SIL 15-WT-15, Rev. A
January, 2017
Page 1 of 5

SUBJECT: xFE Models with Technology to Increase Fuel Economy for BUS

MODELS AFFECTED: B3400, T3280, T3325, and T3375

Figure 1. Main Shaft Exploded View

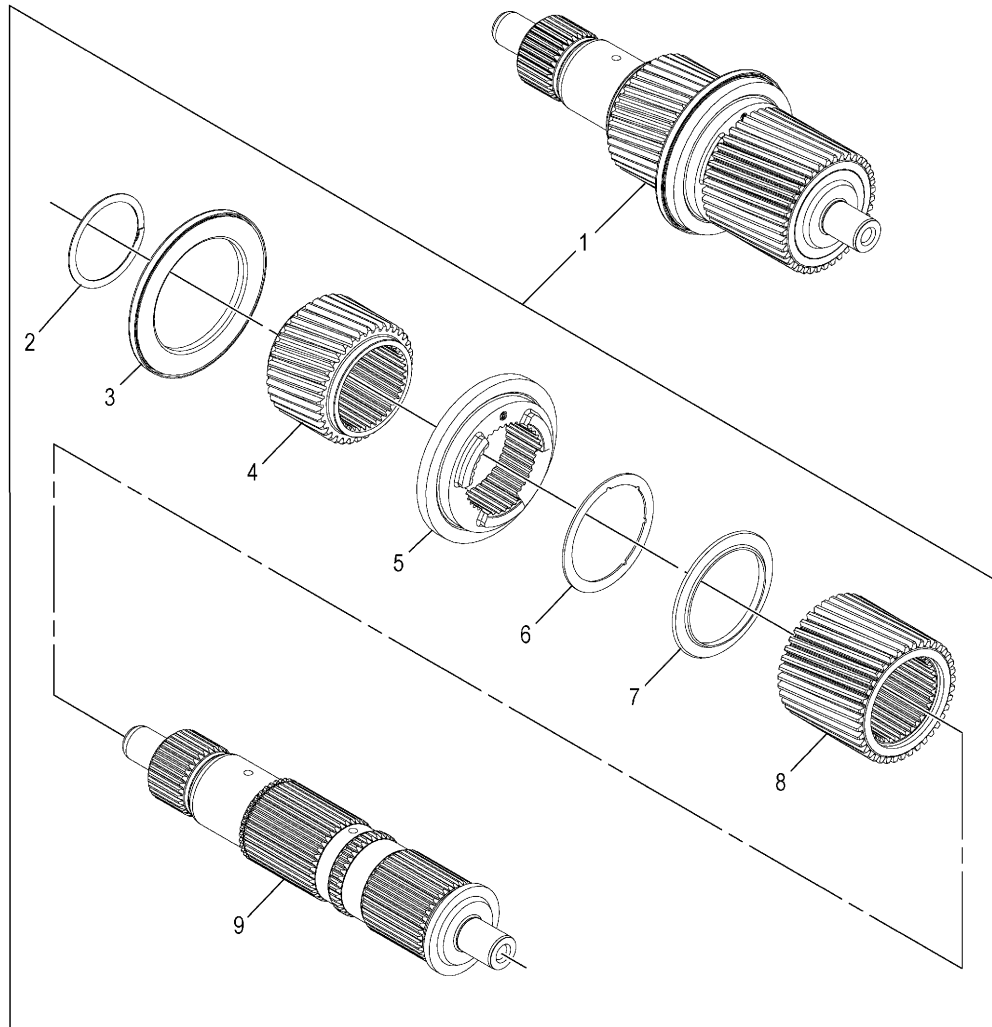
NOTE: The 3000 Series xFE BUS models are configured with a new main shaft group 05-622, wide ratio P2 carrier assembly, and close ratio P3 carrier assembly. In addition, a xFE BUS requires an A61, A62, A63 TCM with a xFE calibration. Units should not be converted from wide or close ratio models to xFE models without prior written approval from the BUS OEM.
